Final Environmental Impact Report

Edgewood Plaza Project

**Palo Alto File No. 08PLN-00157/10PLN-00198
State Clearinghouse No. 2011022030**

**City of Palo Alto
February 2012**

FIGURE 16

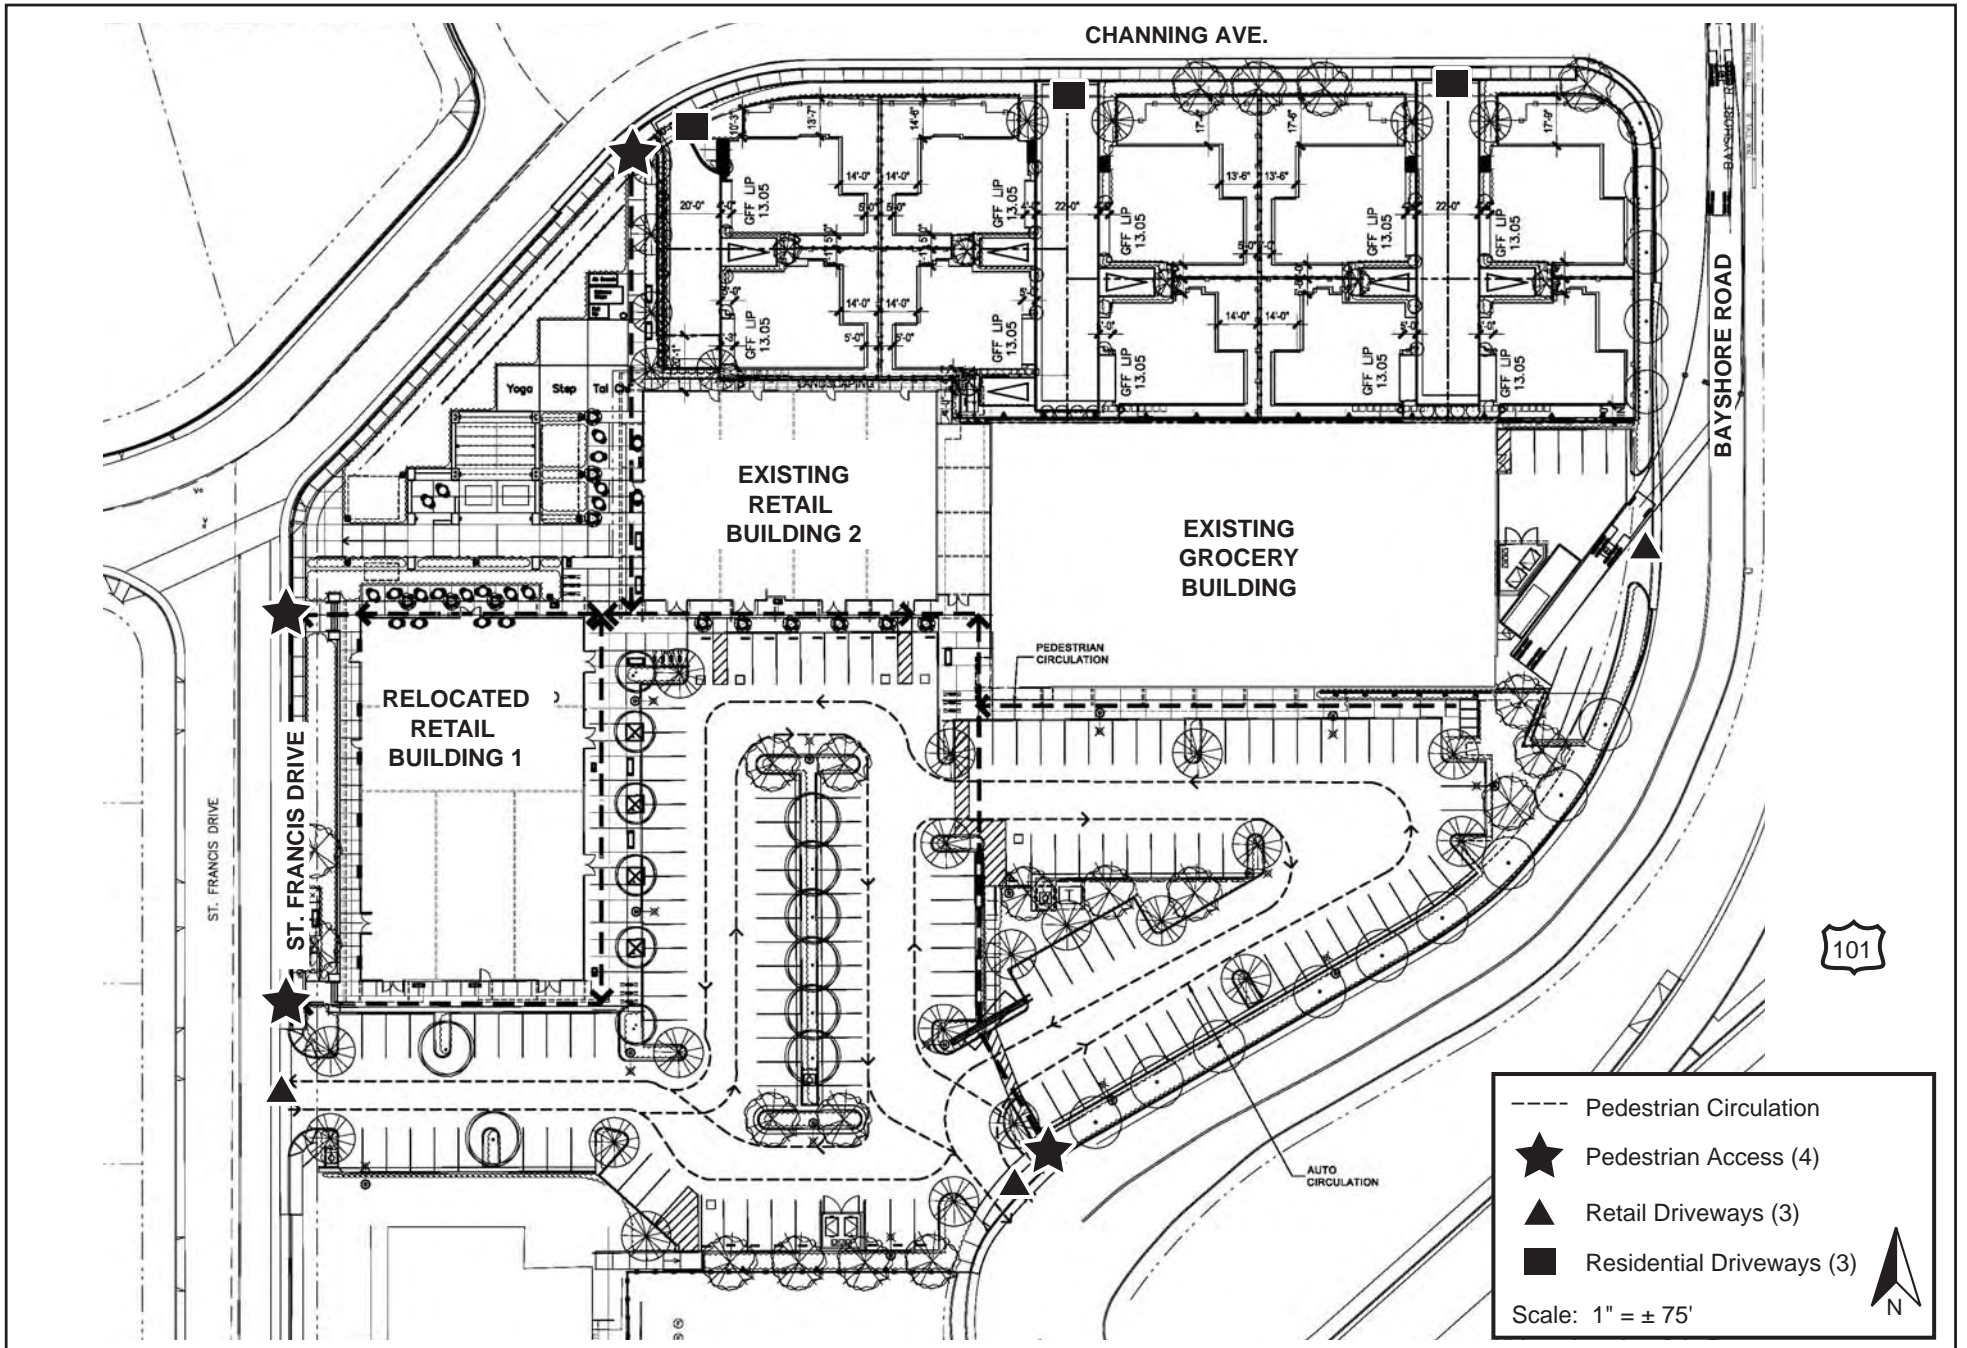
3) The City should require the Project developers to demonstrate how pedestrians and bicyclists will access the Project site from the north along West Bayshore Road. The current shopping center has pedestrian access points at the NE corner (Channing and West Bayshore Road). However, these access points were eliminated in the plans provided for public review in Fall 2010. The “Conceptual Site Plan” in the DEIR (p. 14) does not indicate pedestrian access points.

circulation on the site is addressed on pages 119-120 of the Initial Study (Appendix C to the Draft EIR). A figure that illustrates the description of the proposed pedestrian access to the site has been added to the EIR. Please refer to Figure 16 (insert to Page 120 of Appendix C) in *Section 6.0* of this document.

Page 120: **INSERT** Figure 16, Conceptual Site Circulation, to Section 4.16, Transportation, as shown below.
